STAFF RECOMMENDATION

1601 Russell Street

June 20, 2012

Application: New construction--addition, Setback reduction, Exterior alterations and Setback reduction

A1 EXISTING FRONT ELEVATION (RUSSELL)

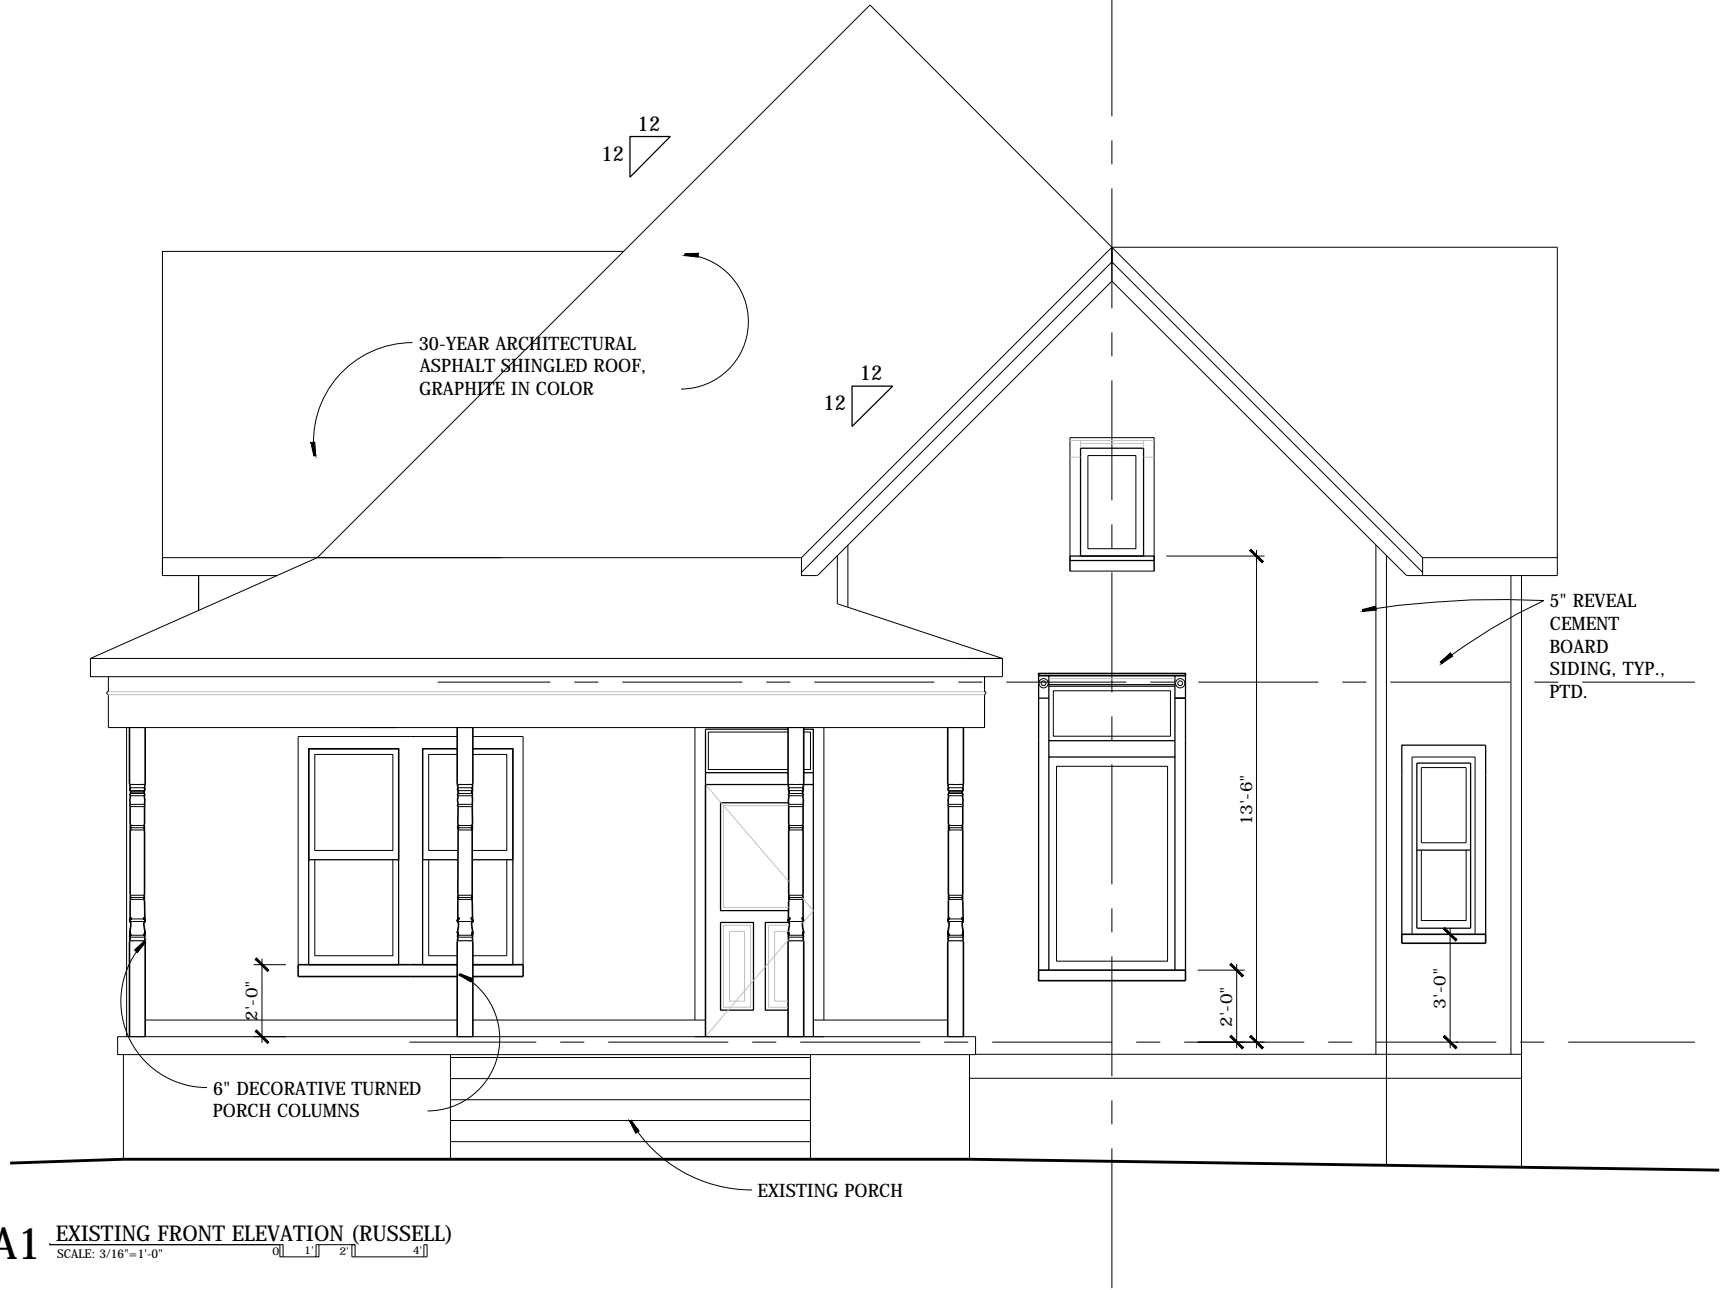
The brick pedestal and wood posts of the front porch was a typical alteration to Victorian era homes as way to modernize them. In this case, they appear to have been there for more than sixty years and have become a part of the building's "story" and history. Staff recommends retaining the existing porch posts. In addition, the original porch post design is unknown and replacing them with a new design could create a false sense of history. With this condition met, the project meets section II.B.4 of the design guidelines.

The applicant proposes to remove the existing non-historic windows of the Queen Anne style historic house. The earliest photograph found so far, shown top right (c.1945), also shows non-historic windows. Since there is no evidence of original dimensions remaining, the applicant has chosen windows that are appropriate for this style of house in terms of proportions; and windows that are a simple design, rather than trying to replicate a diamond-light window which is sometimes found on homes of this era. The replacement windows are all double-hung sashes with the exception of a fixed window with transom on the right bay. Fixed “picture” windows with transoms are not unusual for this style of home. (Existing conditions shown bottom right.) Staff recommends final approval of the windows and for information about the alteration or replacement of any other windows or doors.

F1 FRONT(16TH STREET) ELEVATION
SCALE: 1/8"=1'-0" 0 1 2 4 8

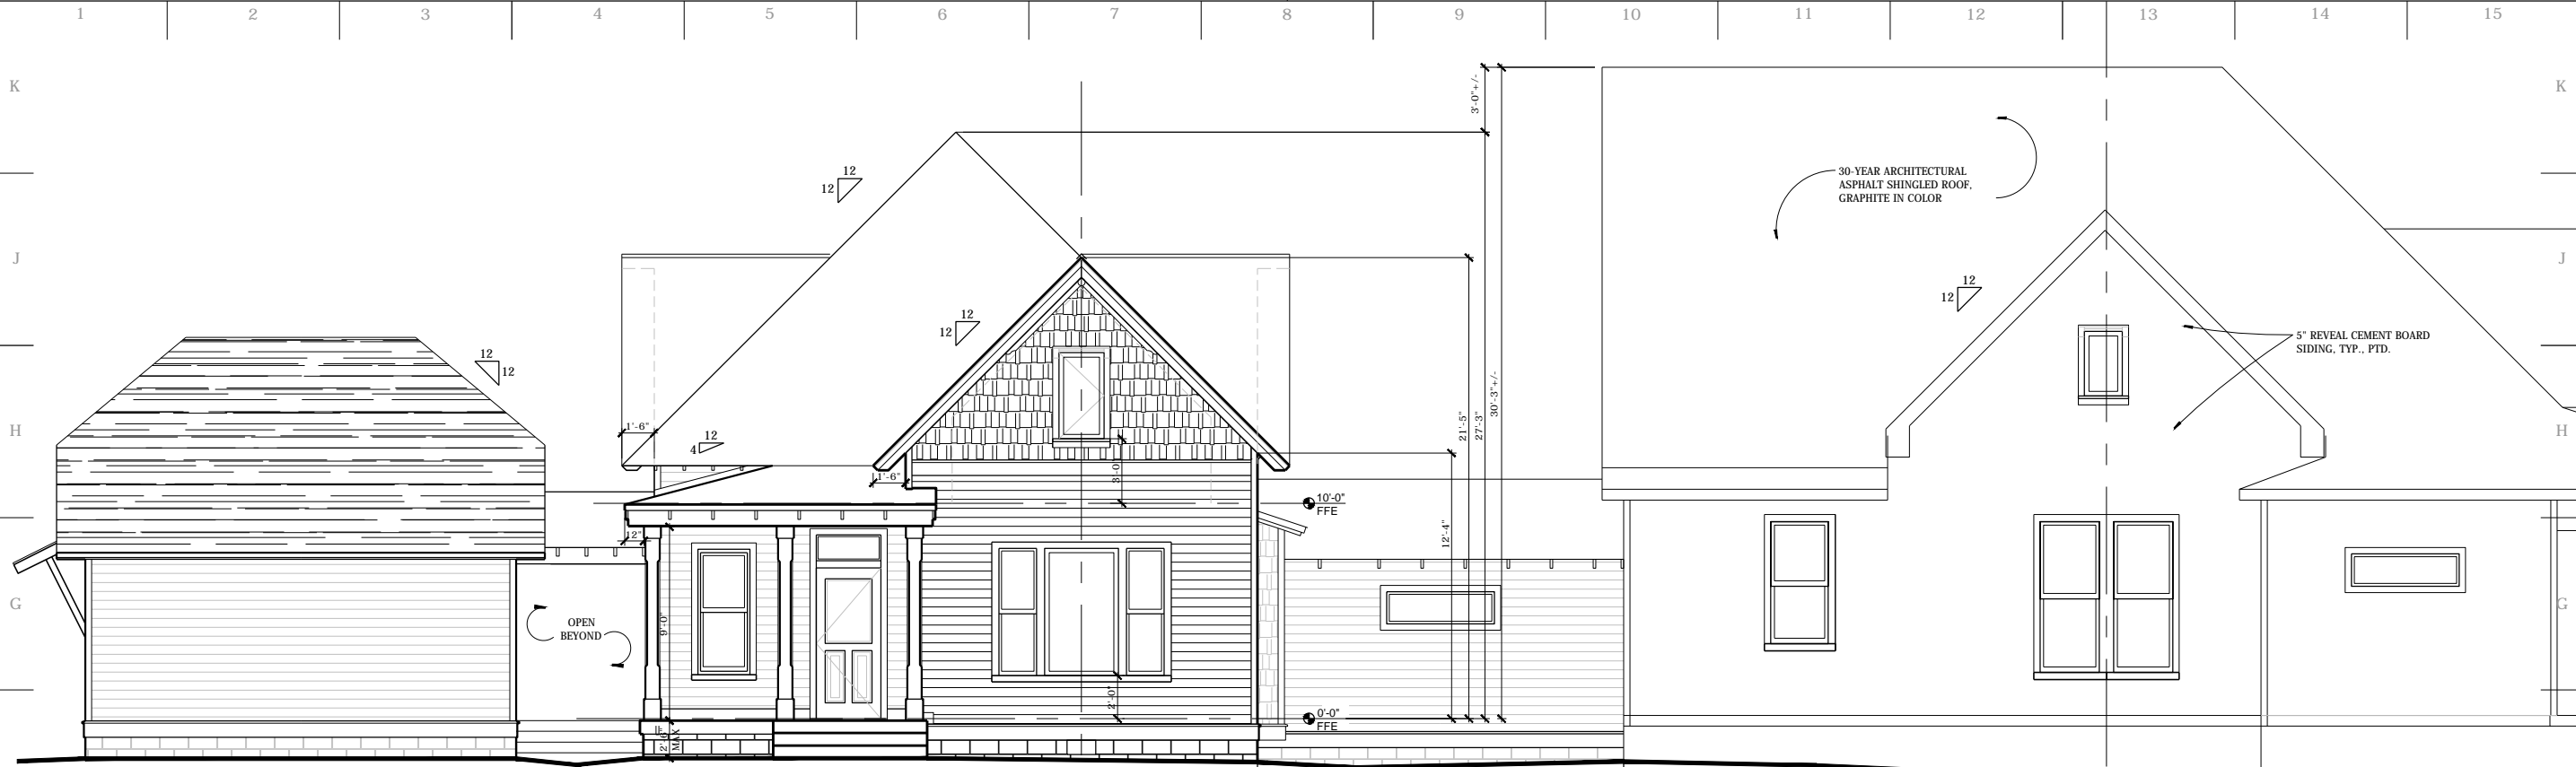
Proportion and Rhythm of Openings: The windows and doors are similar in proportion and rhythm to the existing house, with the exception of the garage. Although garages often did not have windows, the South 16th Street elevation of the proposed garage is highly visible. Two windows would maintain the rhythm of solids to voids seen along South 16th Street and break up this otherwise, blank wall.

1. The applicant submit final material and design specifications for the windows of the addition, vehicular and pedestrian doors, and fencing;
2. The applicant submit information on any other opening alterations for the sides and rear of the existing house;
3. Windows be added to the South 16th Street elevation of the garage;
4. The existing porch posts of the historic house be retained;
5. The vinyl siding of the historic house be removed and the wood siding beneath be repaired, unless staff finds it irreparable; and
6. The mechanicals be located beyond the midpoint of the house.
